Zoning & Subdivision Committee
Thursday, February 8, 2018
12:45 pm

- Minutes from last meeting of January 11, 2018
- 1. Review of Jerome Village Preliminary Plat Extension (Union County) – Staff Report by Brad Bodenmiller
- 2. Review of Jerome Village VN-3 Preliminary Plat (Union County) – Staff Report by Brad Bodenmiller

Staff Report – Jerome Village Preliminary Plat Extension

Re: Jerome Village Preliminary Plat

Date	Job No.
January 3, 2008	2006-1643
Scale	Sheet
1"=400'	6/27

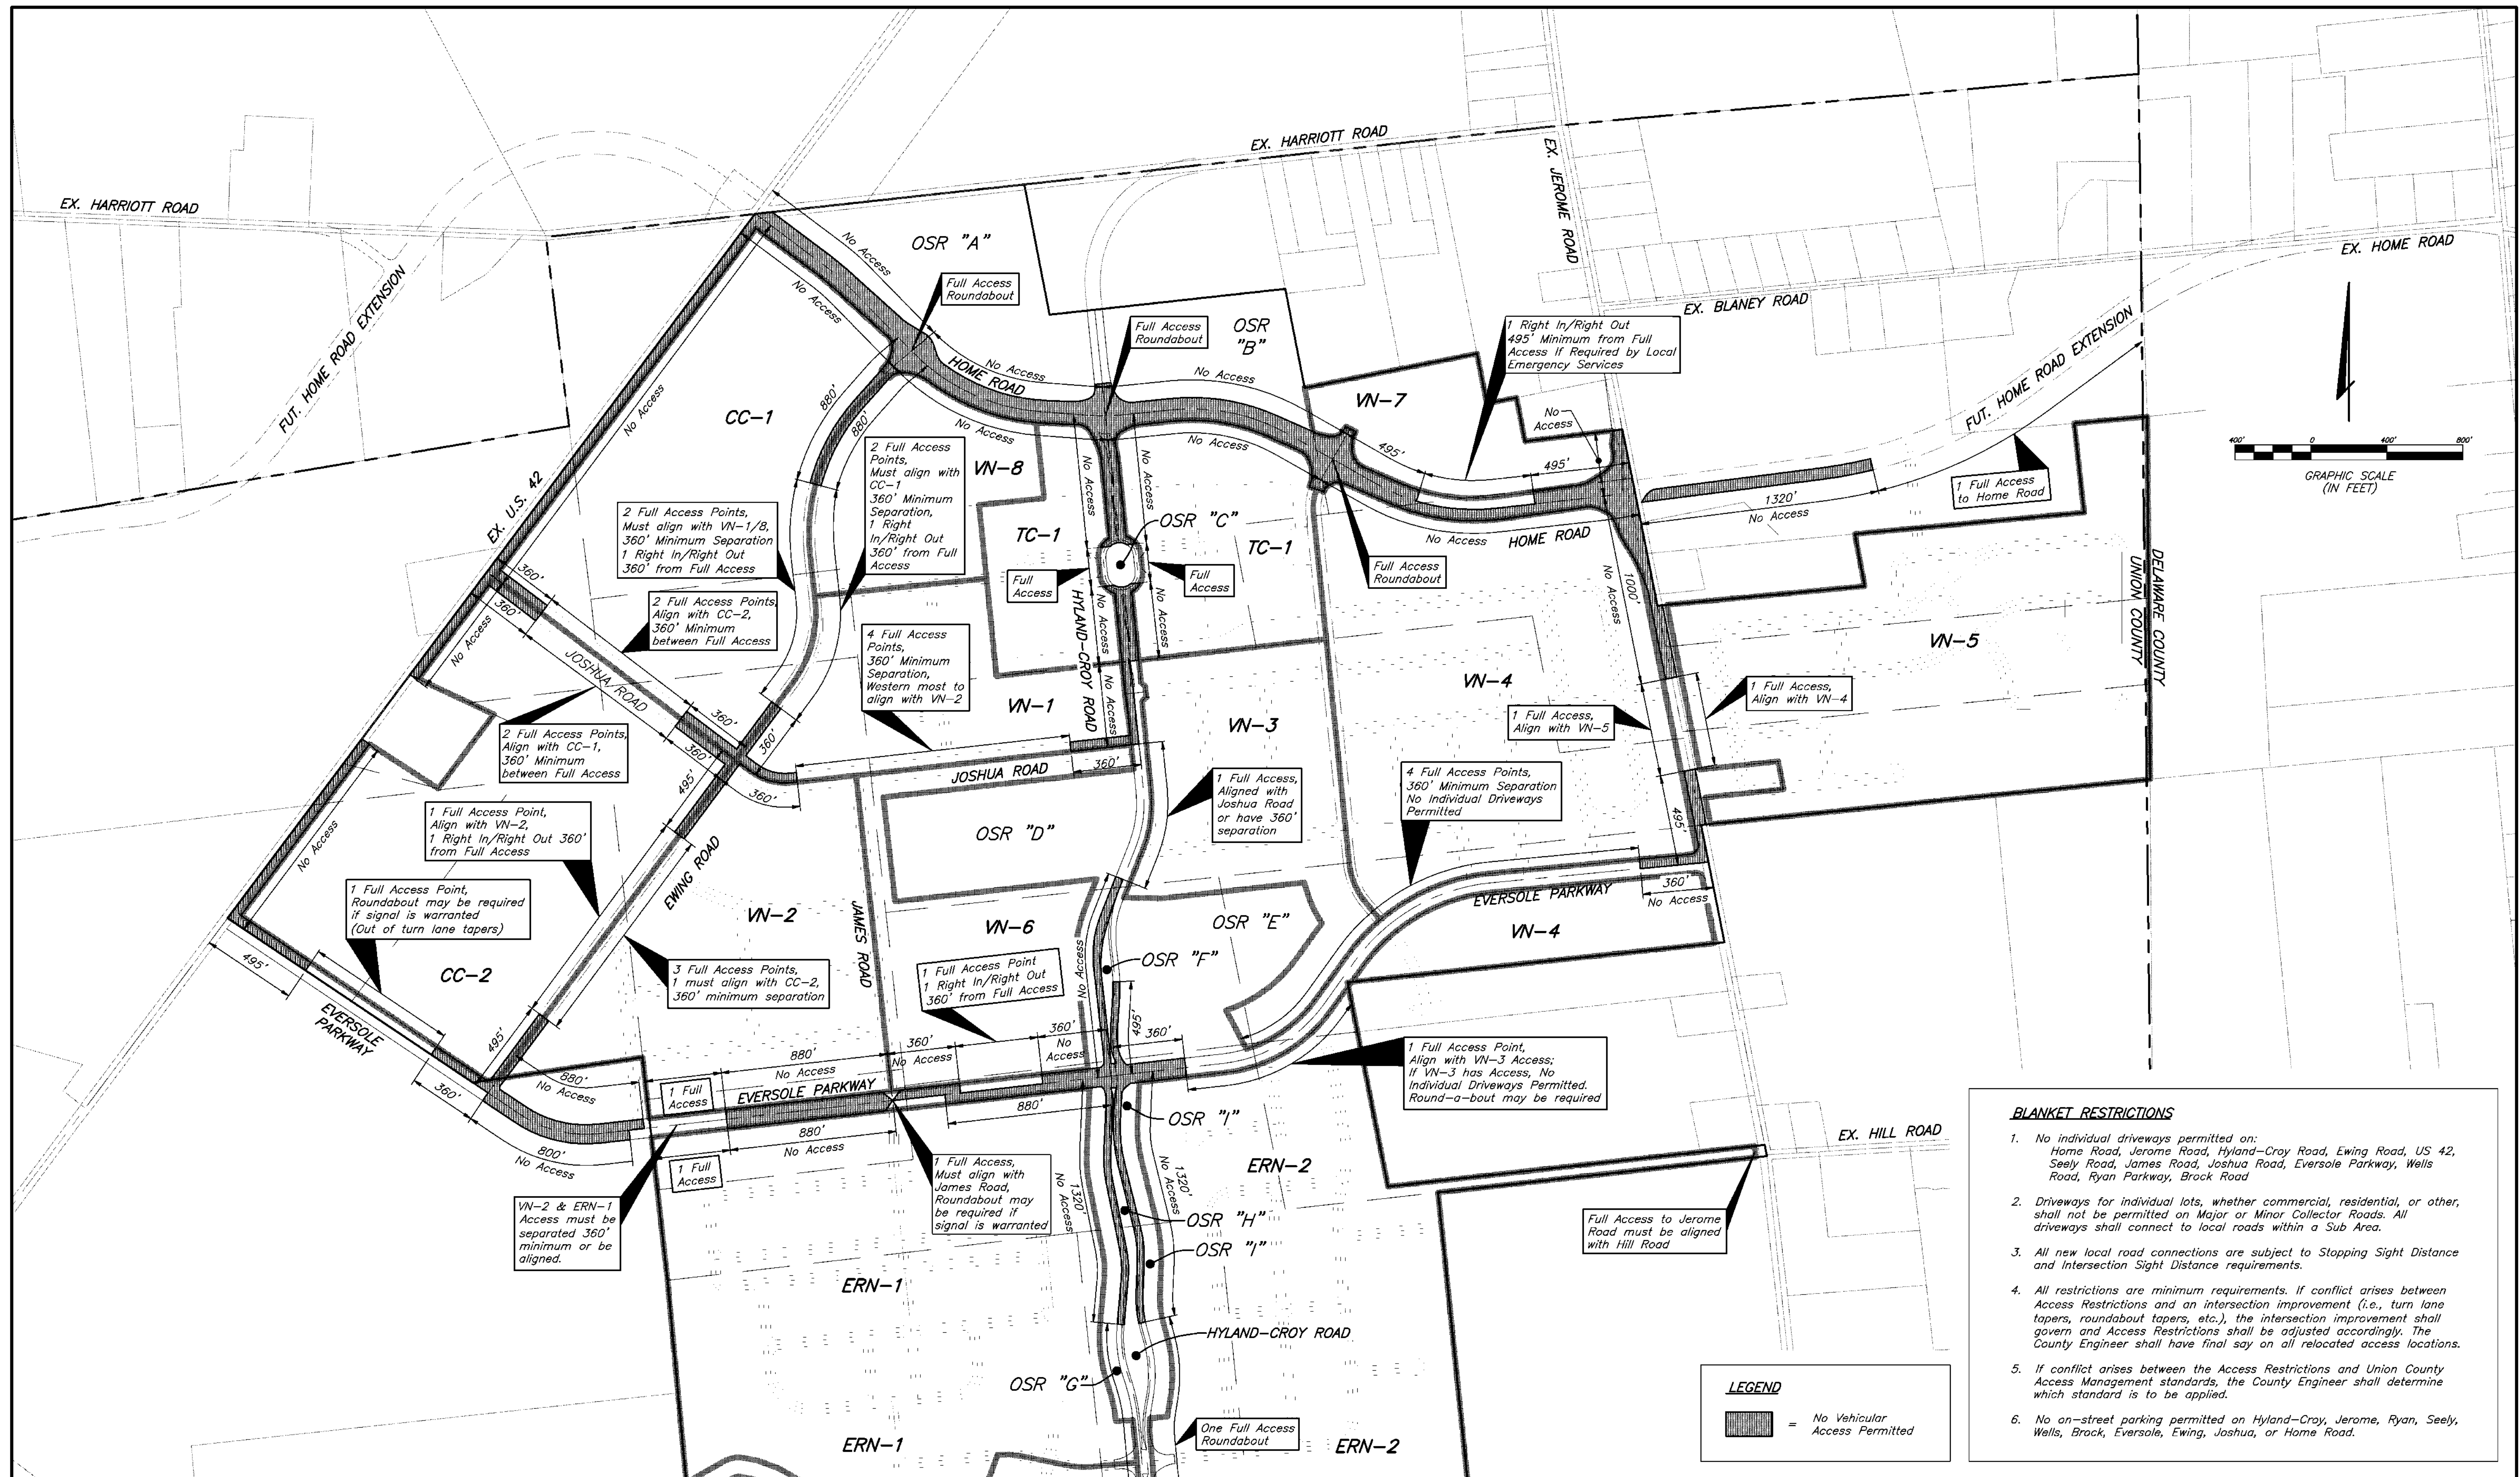
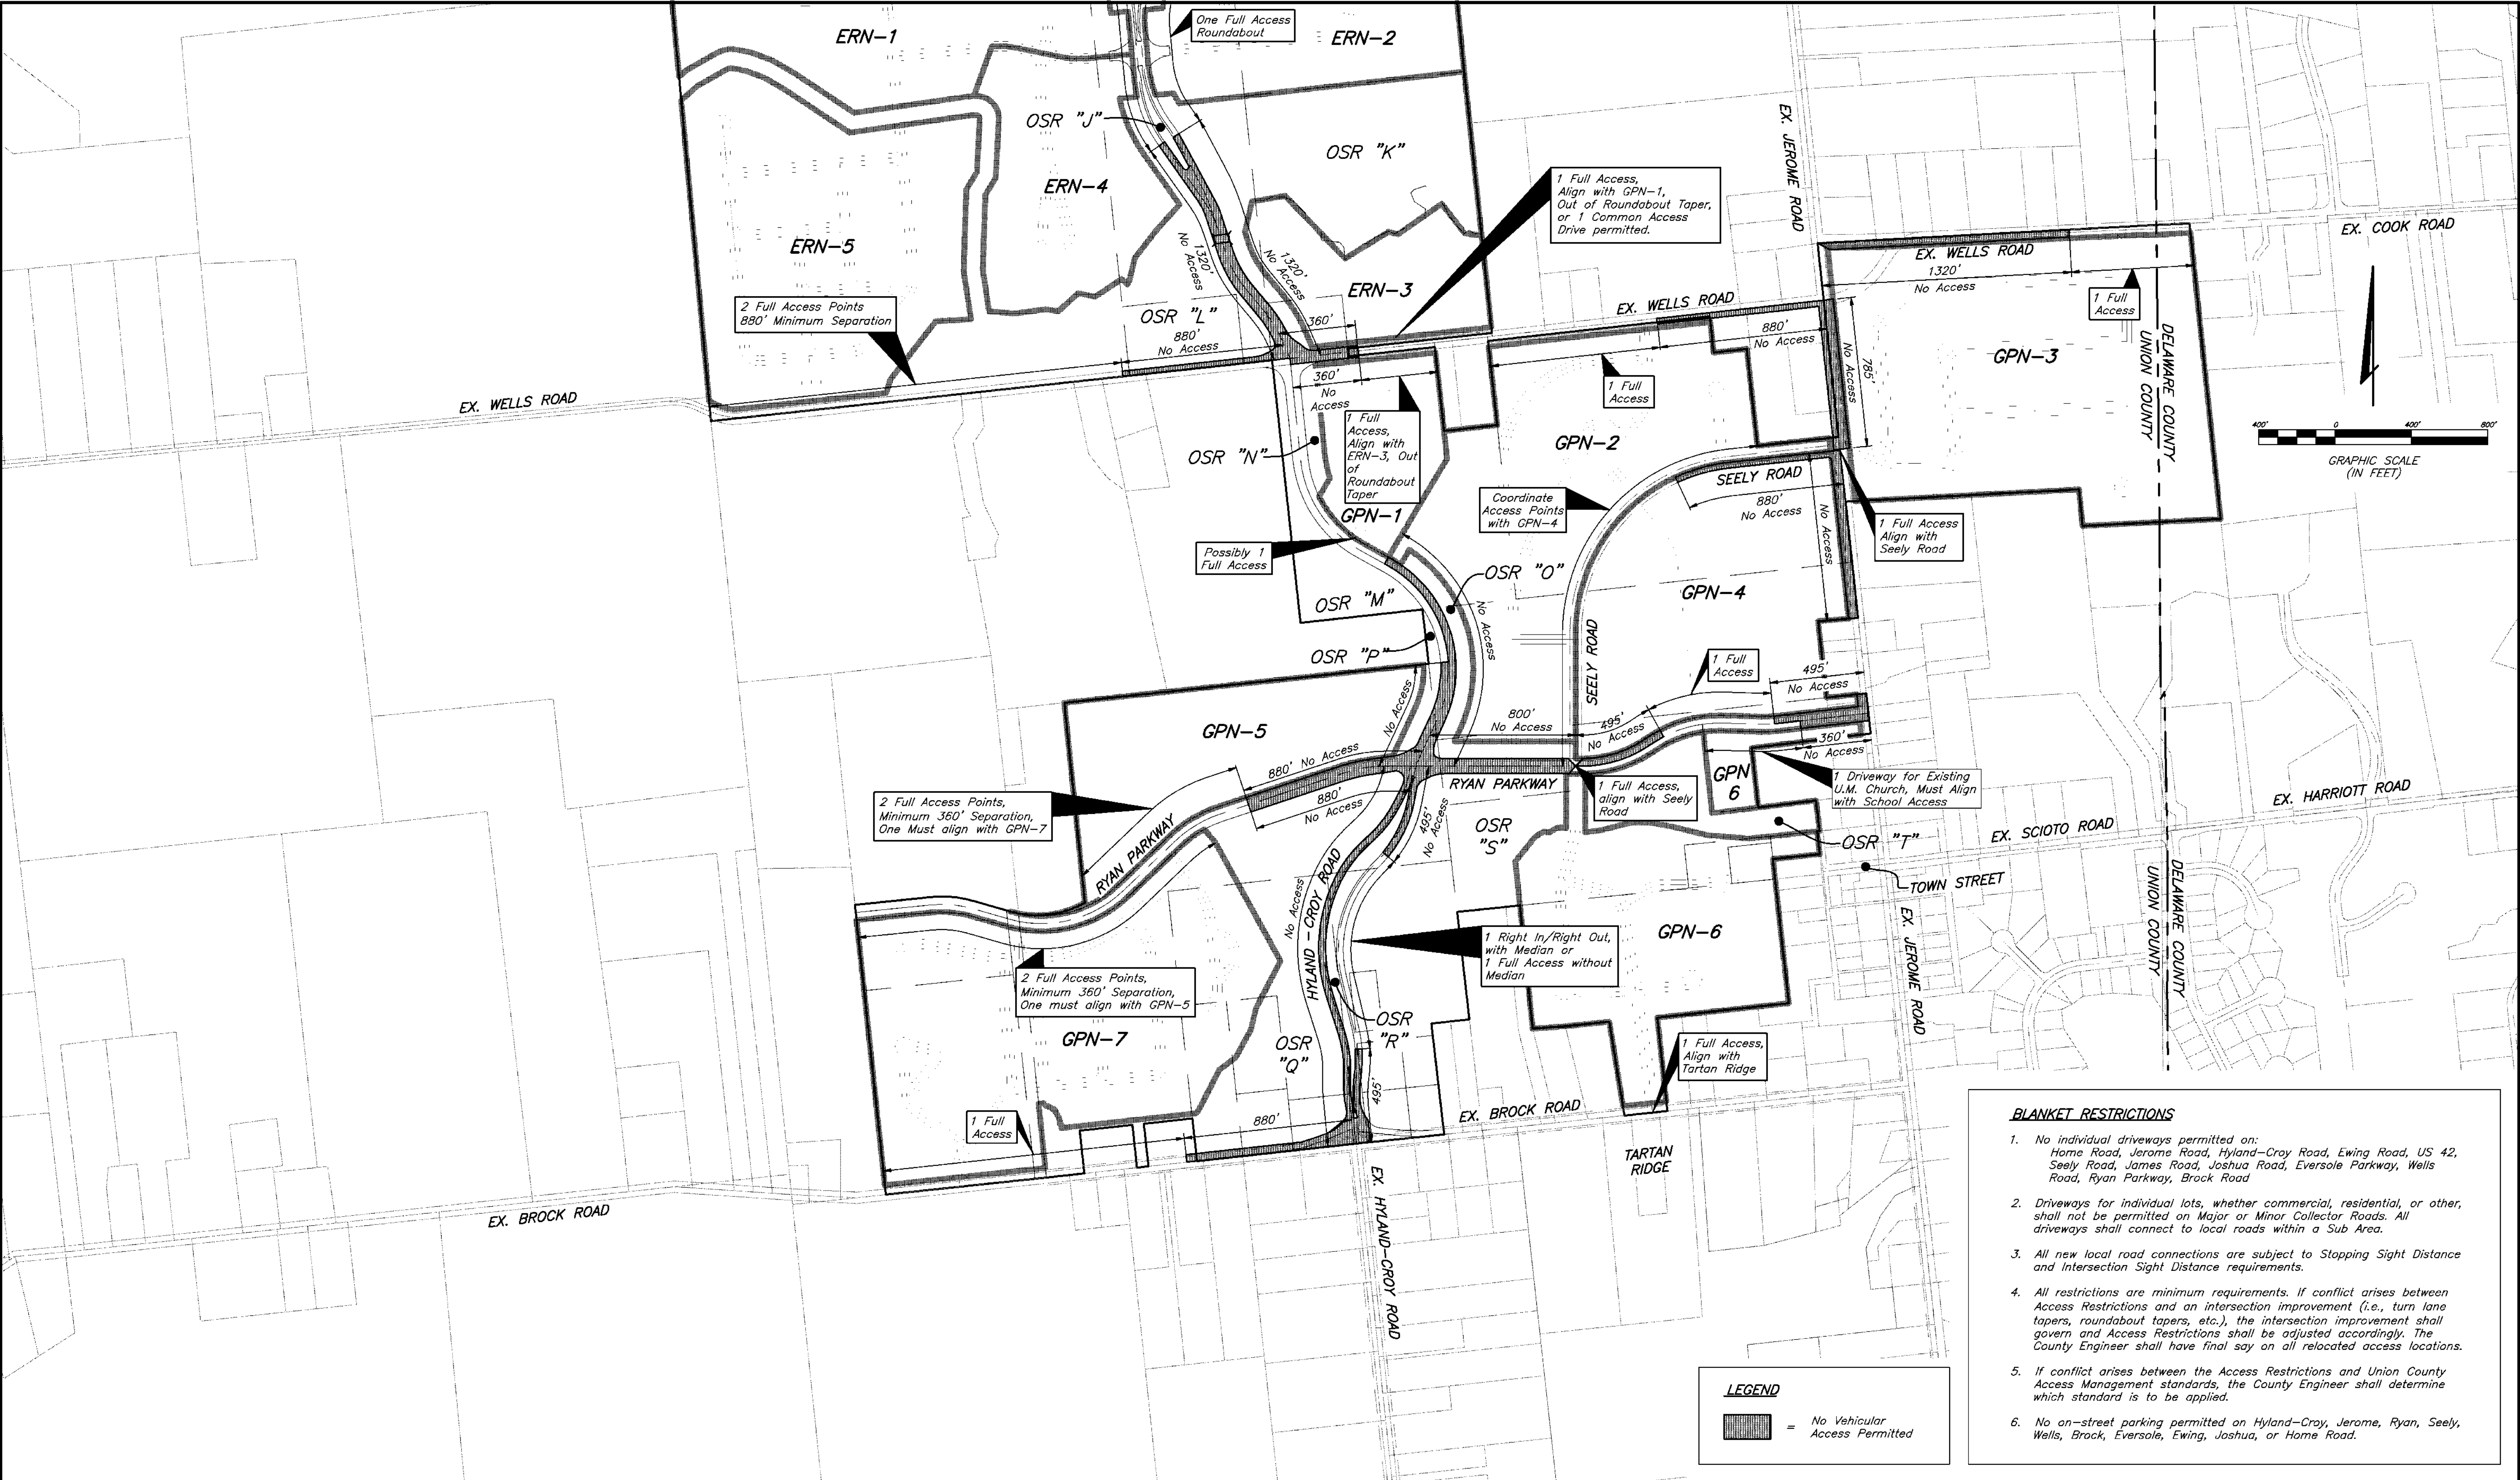
- 15a. The "blanket restrictions" listed on the Access Management Plan shall be restated on the Final Plat.
- 15b. Future local road locations are subject to approval by the Union County Engineer. Final location and design shall be submitted to and approved by the County Engineer prior to platting of lots, groups of lots, or pods.

Date	Job No.
January 3, 2008	2006-1643
Scale	Sheet
1"=400'	24/27

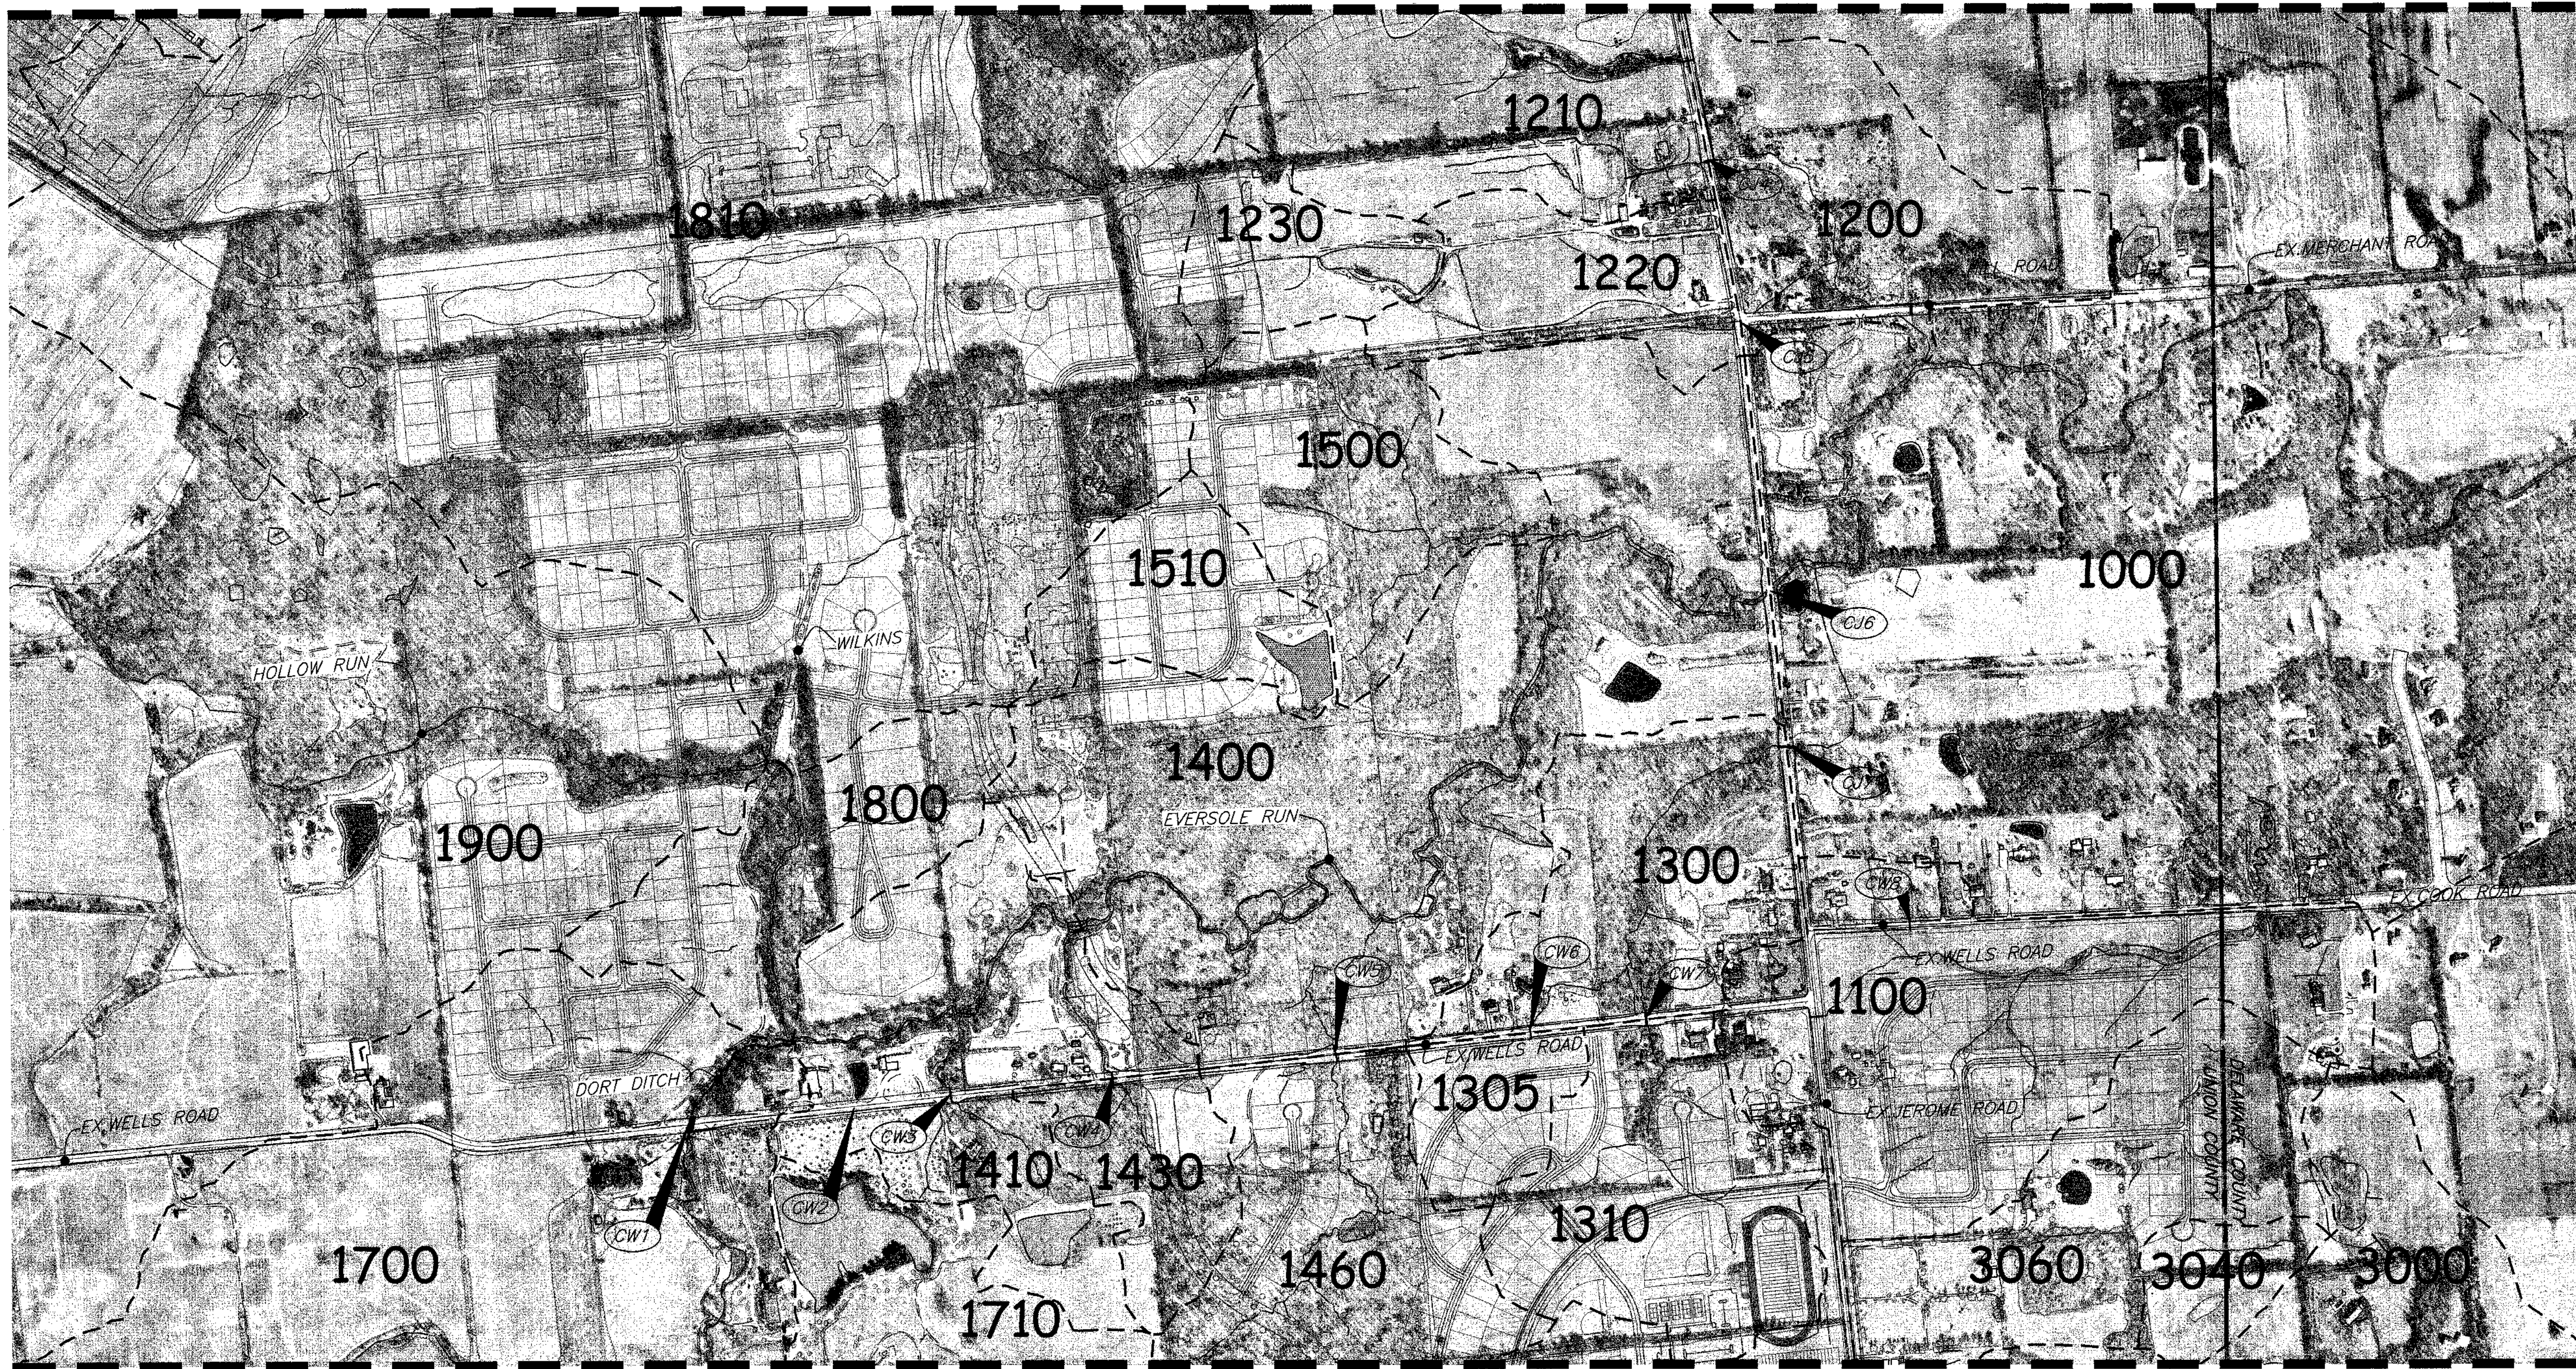
16. Stormwater calculations performed for each subarea/pod shall use the watershed characteristics identified in the Preliminary Plat.
17. Add Union County Standard Deed Restrictions:
